APPENDIX 7: COMMENTS AND RESPONSES ON PROPOSED 2016 MONITORING NETWORK PLAN, REVISION 1

Re: 2016 Monitoring Network Plan, Revision 1 (November 15, 2016)

Figure 2. Expected peak concentration areas per DNR's Labadie designation recommendation modeling.

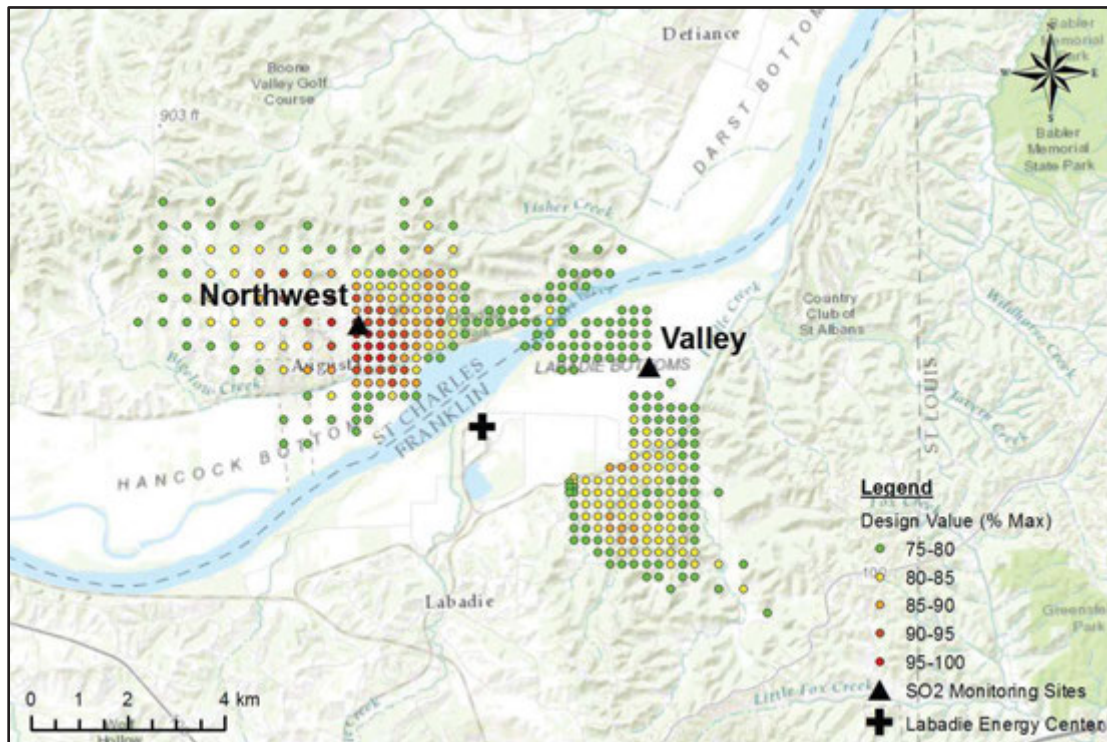
- DNR's modeling for its proposed Labadie designation recommendation, which used newer emissions and meteorological data than Ameren's original modeling, confirmed that the Valley monitor is not located in an expected peak concentration area and predicted an even lower concentration (relative to the peak) at the Valley monitoring site than Ameren's original modeling. This is shown in Figure 2.

Figure 4. Design values and score ranks for the top 300 receptors, DNR modeling based on 2012-2014 emissions.

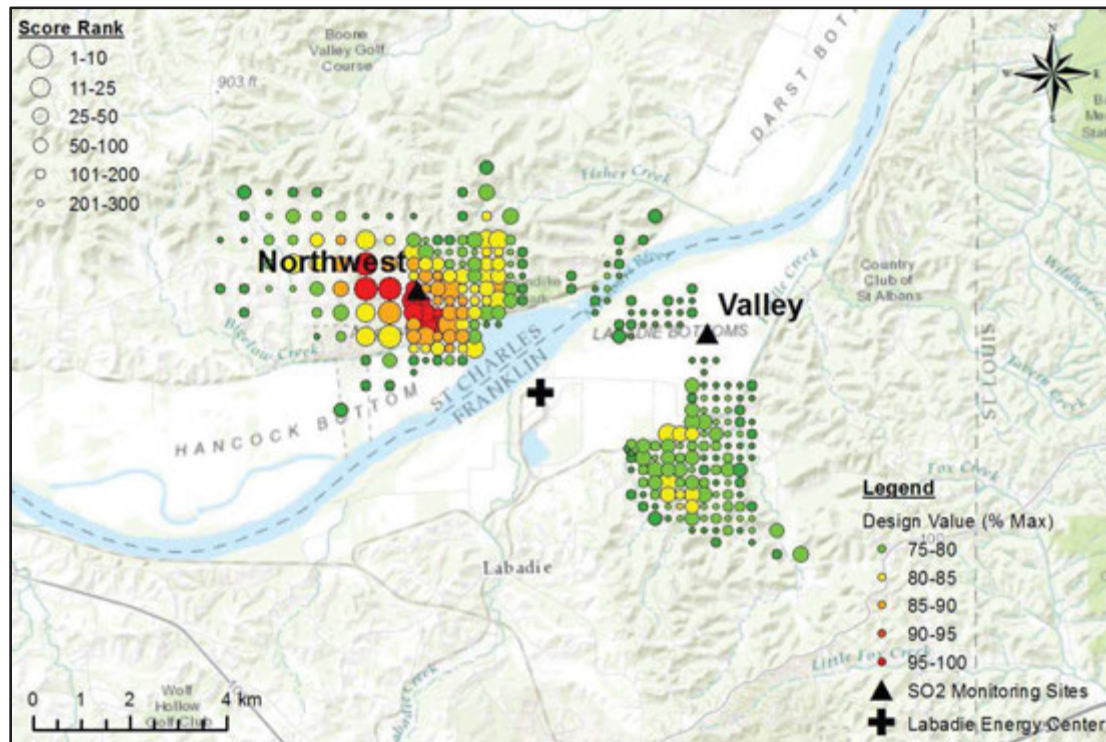
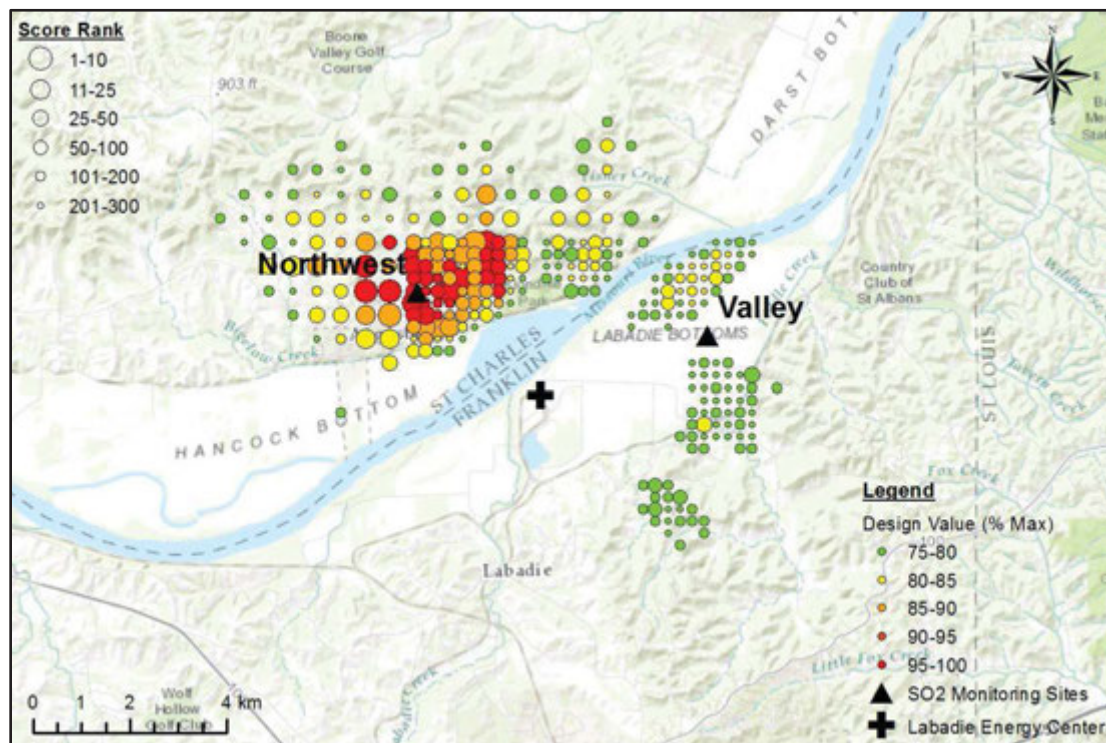
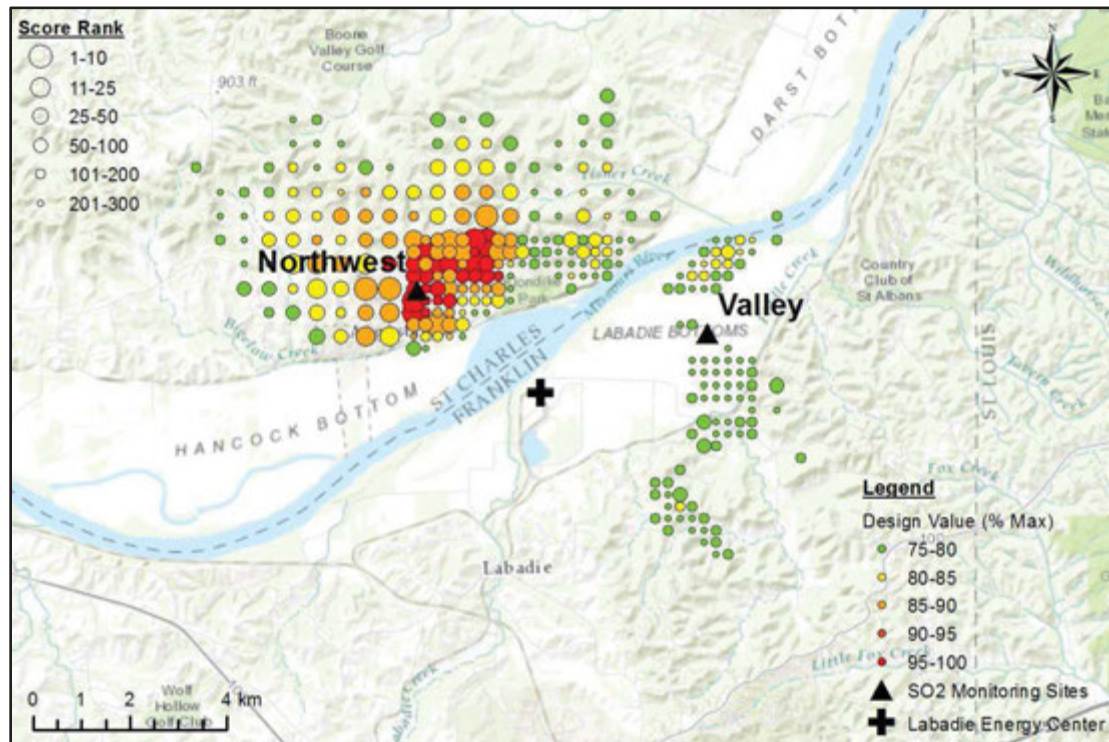
Figures 4, 5, and 6 all show that while the Northwest monitor is sited in an area with high modeled design values and numerous highly ranked receptors, the Valley monitor clearly is not. Regardless of which modeling is used in the analysis, the Valley monitor is sited in an area where there are no top 300 receptors and where the modeled design value is generally less than 75% of the maximum. As such, its location is not on the prioritized list of receptor locations for permanent monitoring sites developed using the scoring strategy described in TAD, and DNR should require that it be moved to a location that is. Figure 4 (based on DNR's modeling with 2012-2014 emissions) shows a large cluster of highly-ranked receptors, including several in the top 25 and many in the top 50, south of the Valley monitor, while Figures 5 and 6 (based on DNR's modeling with 2013-2015 emissions) show a smaller cluster of top 100/200 receptors north of the Valley monitor. It should be noted that, as we discussed in our April 2015 comments on the Labadie QAPP, Ameren's original analysis of the Labadie monitoring sites showed very high modeled design values in both of these areas, yet Ameren still chose to site the Valley monitor where modeled design values were considerably lower.

Figure 7. Design values and score ranks for the top 300 receptors, Ameren modeling based on 2013-2015 emissions, KJEF met, and East St. Louis background.

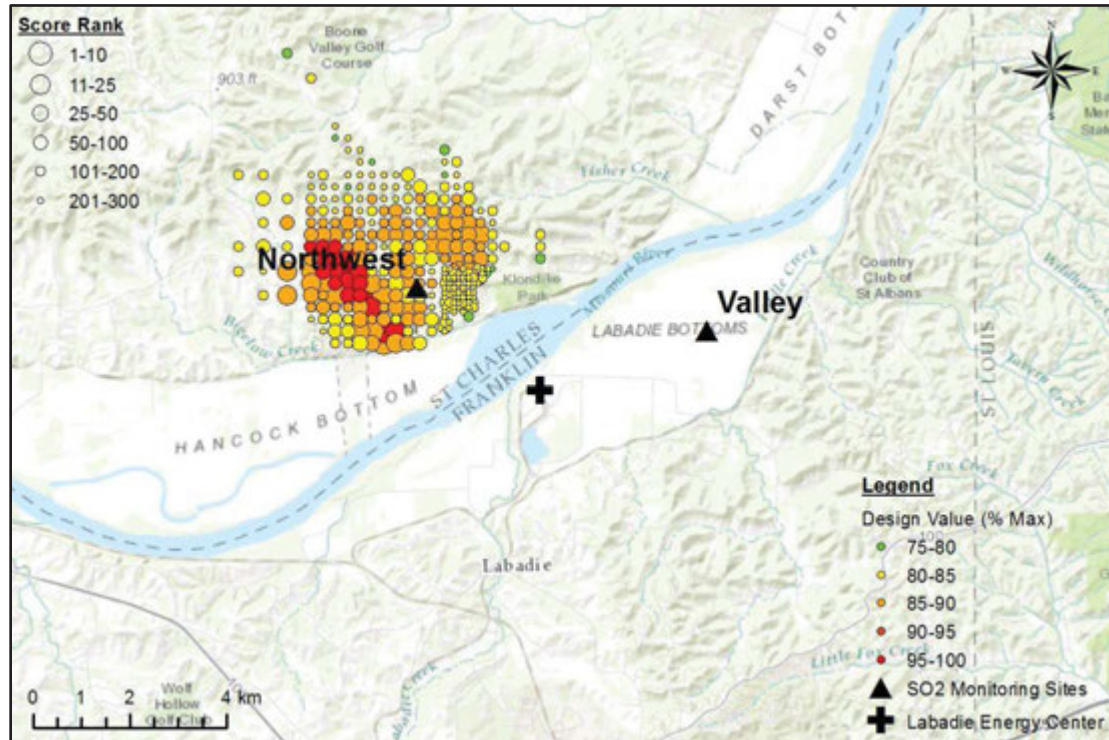
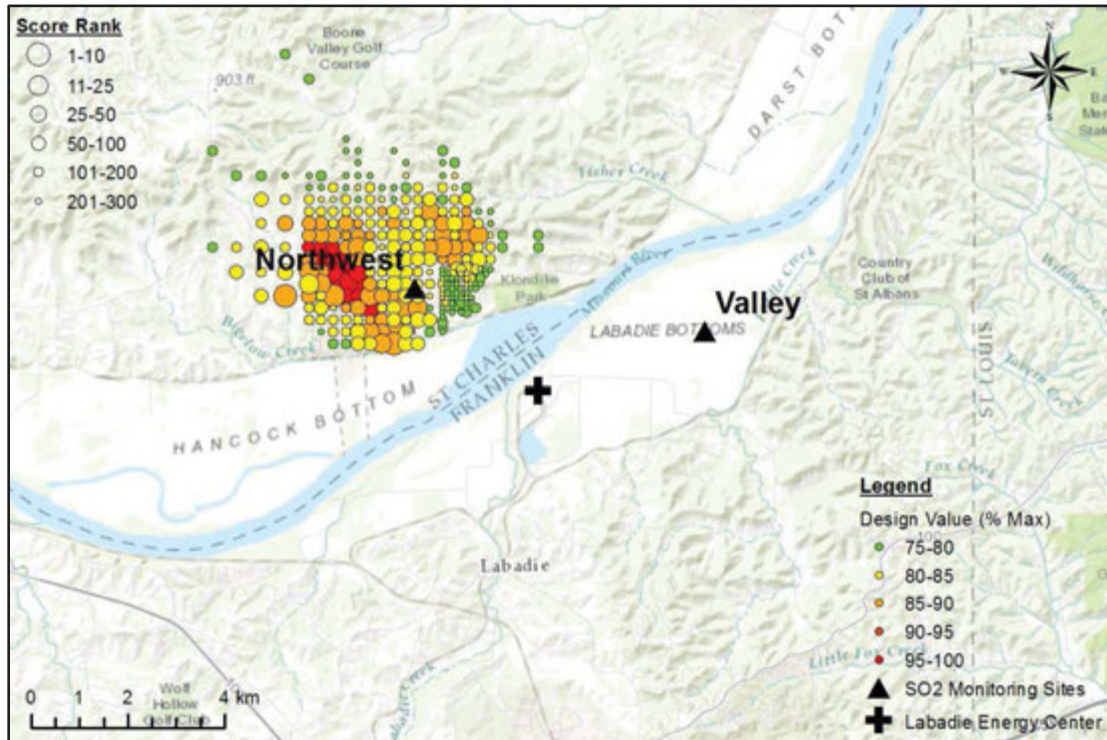
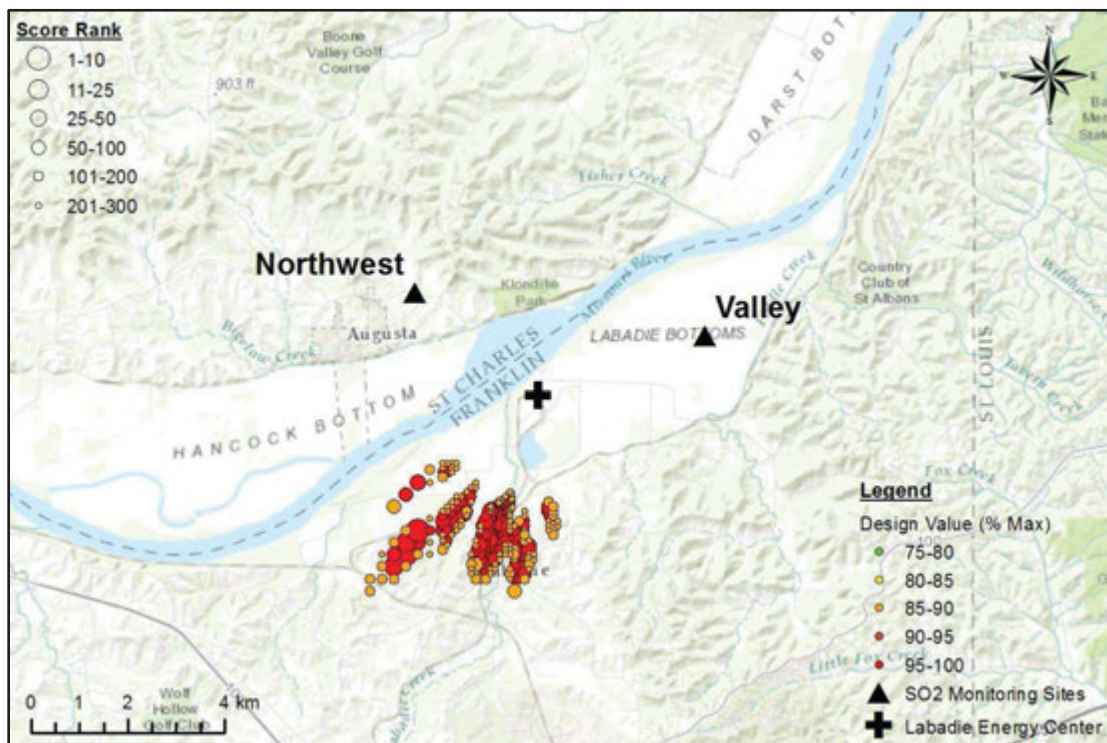
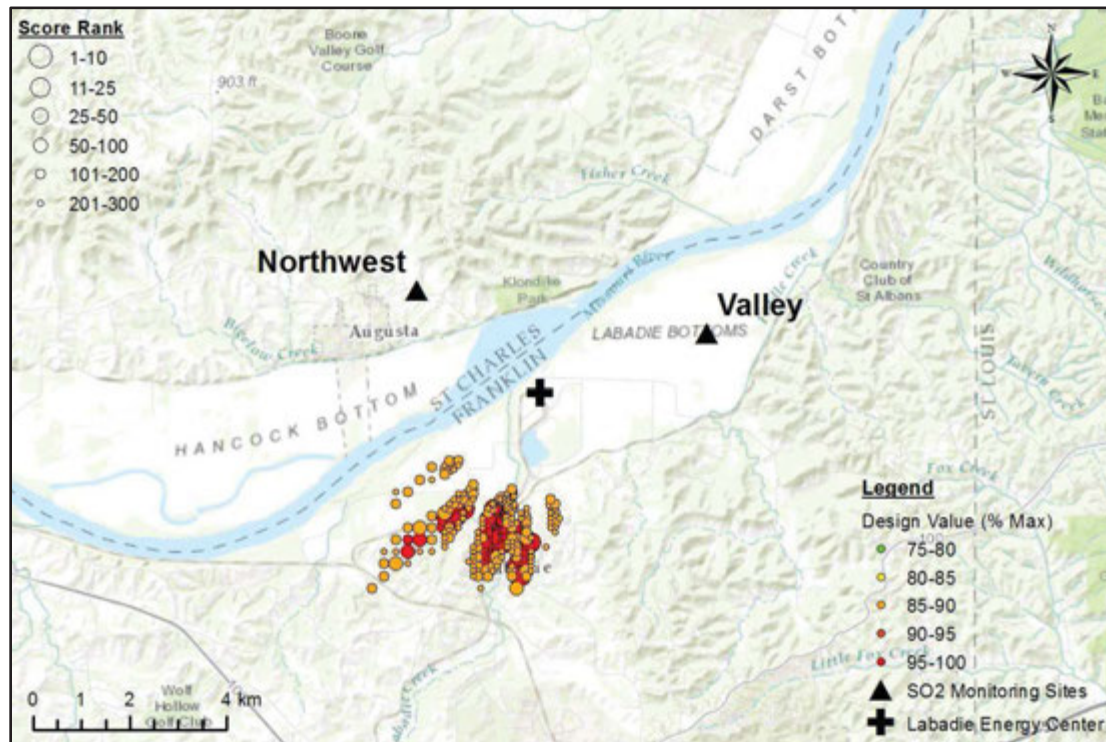
Because Ameren used a much finer receptor spacing than DNR, Ameren's top 300 receptors are much more concentrated than DNR's, limiting to some degree the conclusions that can be drawn from Ameren's modeling without swapping out Ameren's receptor grid for DNR's and re-running Ameren's models. Still, Figures 7 and 8 show that based on Ameren's KJEF model runs, the Valley monitor is sited where there are no highly ranked receptors and the modeled design value is less than 75% of the maximum. Hence, these runs support the conclusion – drawn from our analysis of DNR's latest modeling – that the Valley monitor should be relocated.

Figures 9 and 10, on the other hand, show that based on Ameren's KSUS model runs, *neither* of the Labadie monitors is sited in an expected peak concentration area. The highest modeled design values, as well as the highest ranked receptors, are located south-southwest of the plant. There are no highly ranked receptors, and modeled design value are generally less than 75% of the maximum, at both the Valley and Northwest monitoring sites. As demonstrated in our supplemental comments on the 2015 Monitoring Network Plan (Ex. 3 attached hereto) preliminary meteorological data from the Valley site indicate that KSUS meteorological data is more representative of meteorological conditions at Labadie than KJEF meteorological data. Given that expected peak concentration areas are dramatically different when KSUS meteorological data are used, DNR should require one or more additional monitors in the peak concentration areas shown in Figures 9 and 10 in addition to the two existing monitors (one of which should be relocated). Failure to monitor these areas would result in failure to detect ground-level SO₂ concentrations maxima if KSUS meteorological data ultimately prove more representative of the area than KJEF meteorological data.

Figure 11. Expected peak concentration areas per Ameren’s modeling for its analysis of SO₂ and meteorological monitoring sites around Rush Island.

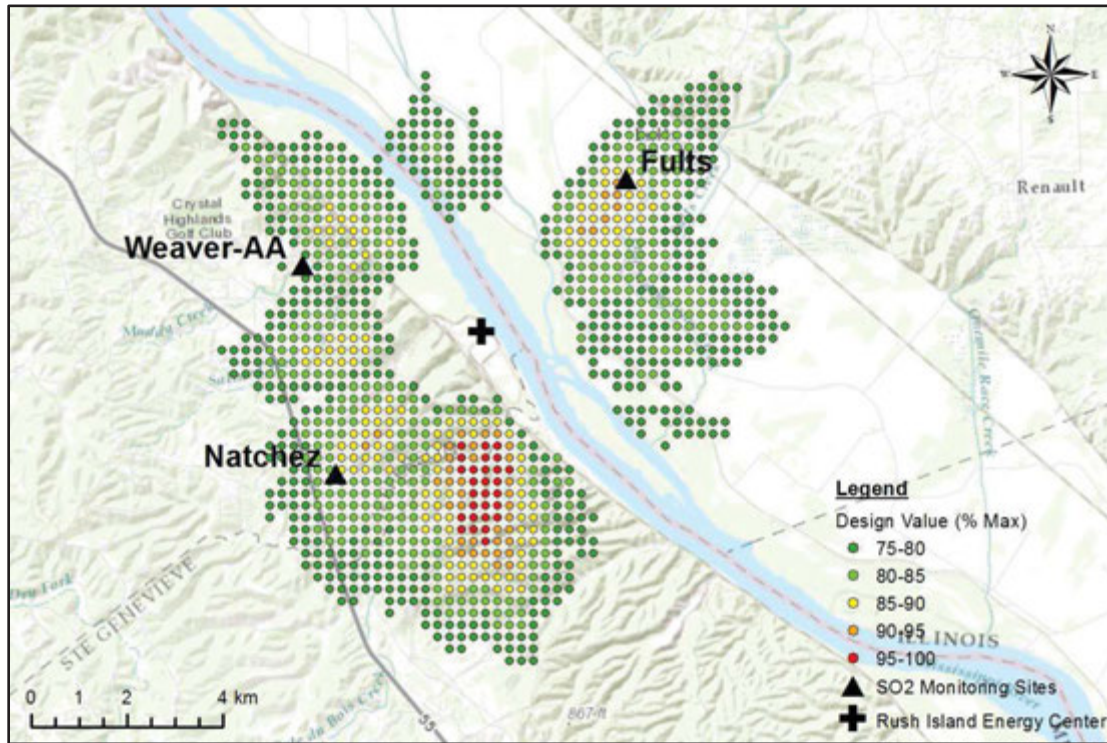
- Ameren's modeling for its analysis of SO₂ and meteorological monitoring sites around Rush Island identified one large and four smaller areas where peak 1-hour SO₂ concentrations are expected to occur. These areas are shown in Figure 11. However, none of the Rush Island monitors are located in the large peak concentration area south of the plant, which is also where the highest modeled concentrations occur. Furthermore, while two of the monitors – Fults and Natchez – are located on the periphery of two of the smaller expected peak concentration areas, the Weaver-AA monitor is not located in an expected peak concentration area at all.

Figure 16. Comparison of polygons used in DNR’s original and supplemental analyses.

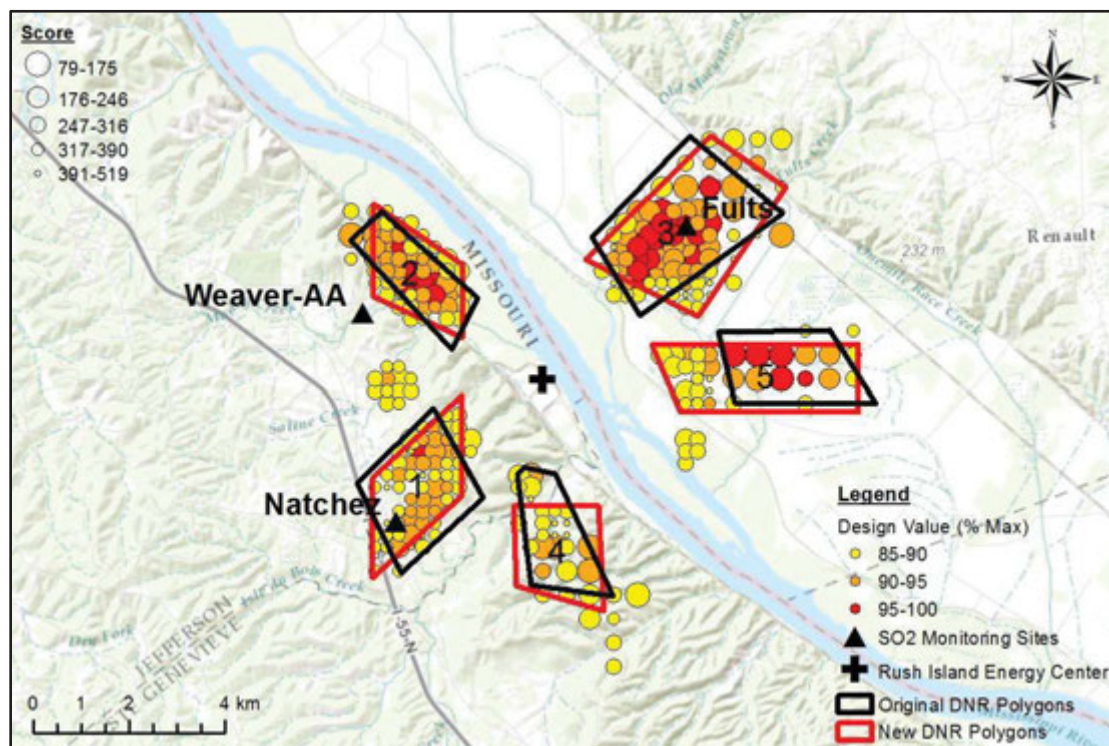
- 2) The polygons used in DNR's supplemental analysis are a different size and shape than the ones used in its original analysis. This is shown in Figure 16. Setting aside the bias inherent in DNR's methodology owing to its use of a telescoping receptor grid, the supplemental analysis should use the same polygons as the original analysis if polygon rankings based on receptor counts are going to be compared.

Figure 17. Receptors with the 10, 25, 50, and 100 highest score ranks (clockwise from upper left). Peak concentration areas (design value $>90 \text{ ug/m}^3$) are shaded red.

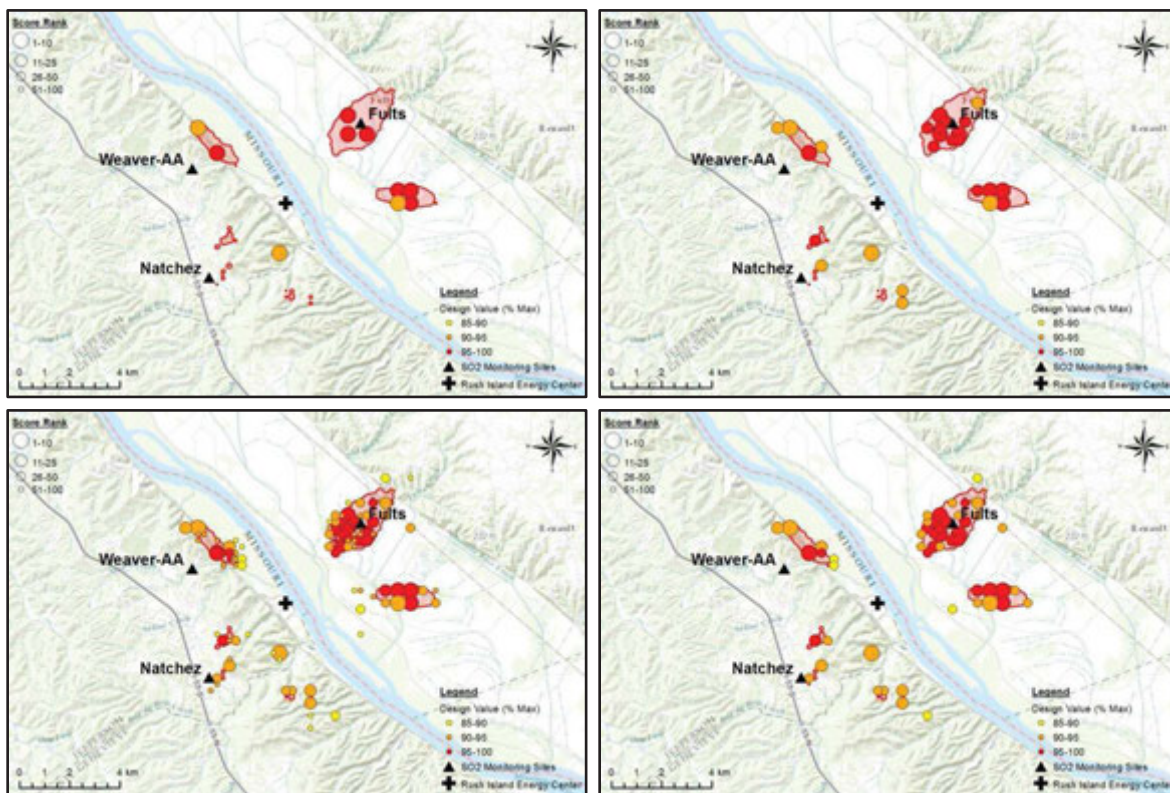
Had DNR followed the scoring strategy described in the TAD through to the end, and ranked receptors by their scores to come up with a list of locations ranked in general order of desirability with regard to monitor siting, its supplemental analysis would have reached a different conclusion regarding the siting of the Rush Island monitors. Figure 17 shows the 10, 25, 50, and 100 receptors with the highest score ranks superimposed on the peak concentration areas (design value $>90 \text{ ug/m}^3$). The 10 receptors with the highest score ranks would be the most desirable monitor locations, and all but one are clustered in the three largest peak concentration areas, which are where the Rush Island SO_2 monitors should have been sited. The fact that almost all of the 10 highest ranked receptors – taking into account modeled design values *and* frequency of having the highest 1-hour daily maximum concentration – are located in these areas only reinforces that point. Similar results are obtained by looking further down the priority list at the 25, 50, and 100 highest ranked receptors, the vast majority of which are located in the same three peak concentration areas.

Only one of the three Rush Island monitors is sited in these peak concentration areas. The Fults monitor is sited in the large peak concentration area located northeast of the plant, which contains three of the 10 highest ranked receptors and upwards of half of the 100 highest ranked receptors. The Natchez and Weaver-AA monitors, however, are located outside of the large peak concentration areas east and northwest of the plant, which collectively contain six of the 10 highest ranked receptors about 25 of the 100 highest ranked receptors. DNR should require Ameren to relocate the Natchez and Weaver-AA monitors to these areas, as they clearly represent – along with the area where the Fults monitor is located – the areas where peak concentrations are expected to occur based on DNR’s own modeling and the receptor scoring strategy described in the TAD.
